MEMORANDUM – S67 MATTERS

Subject: **Fast-Track Approvals Act 2024 (FTAA) – FTAA-2503-1039 - Sunfield Fast-track Proposal – section 67 matters (AC ref BUN60447430)**

Date: 16 June 2025

Figure 1 Catchments

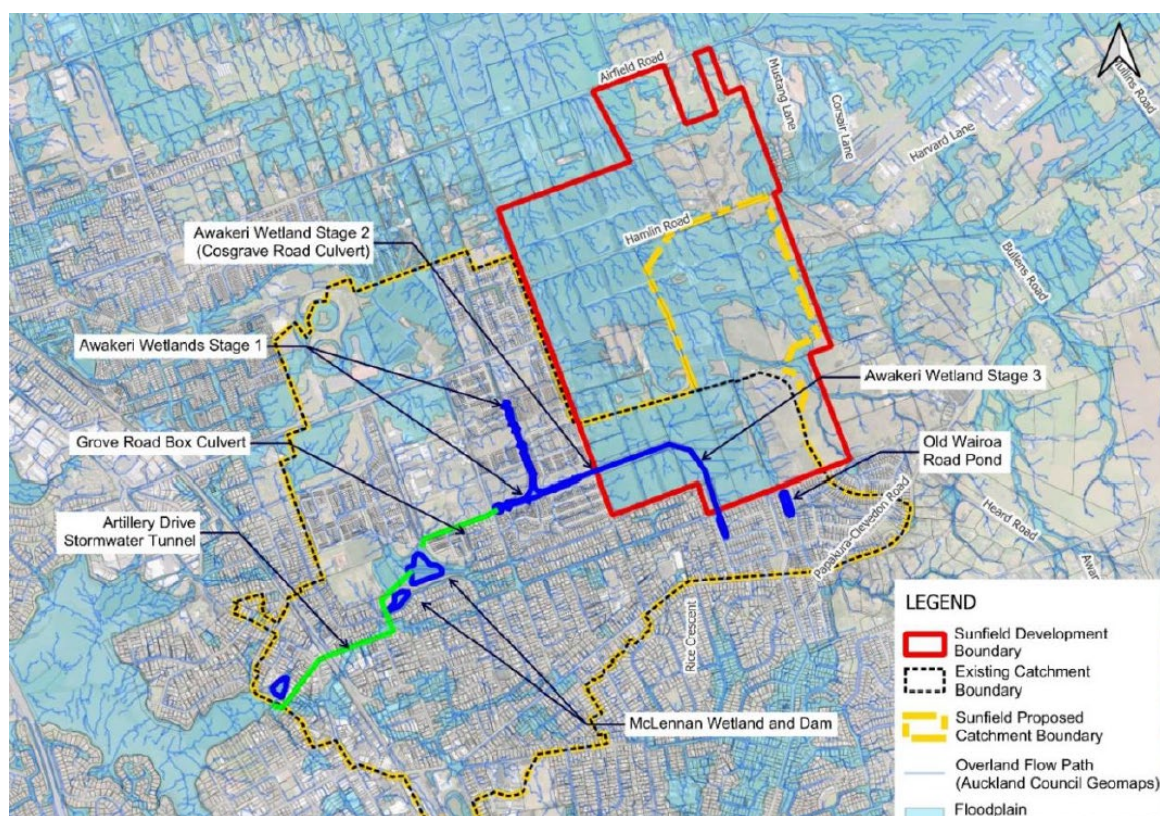
To mitigate the adverse effects of increased flooding caused by the proposed development, the Applicant has proposed a complex scheme of stormwater attenuation ponds and catchment diversions. This includes diverting approximately 55 hectares of catchment from the Papakura Stream catchment to the Pahurehure Inlet catchment, as shown in **Figure 1** below.

Given the substantial additional catchment area proposed to be diverted to the Awakeri wetlands, Auckland Council has serious concerns about the hydraulic and water quality capacity of the existing infrastructure. Auckland Council holds a Designation for the Awakeri Wetlands. Before authorising any connections to the stormwater system or permitting the Applicant to proceed as Council's Agent for the Outline Plan of Works for Awakeri Wetlands Stages 2 and 3 the additional catchment area will need to have an authorised discharge consent.
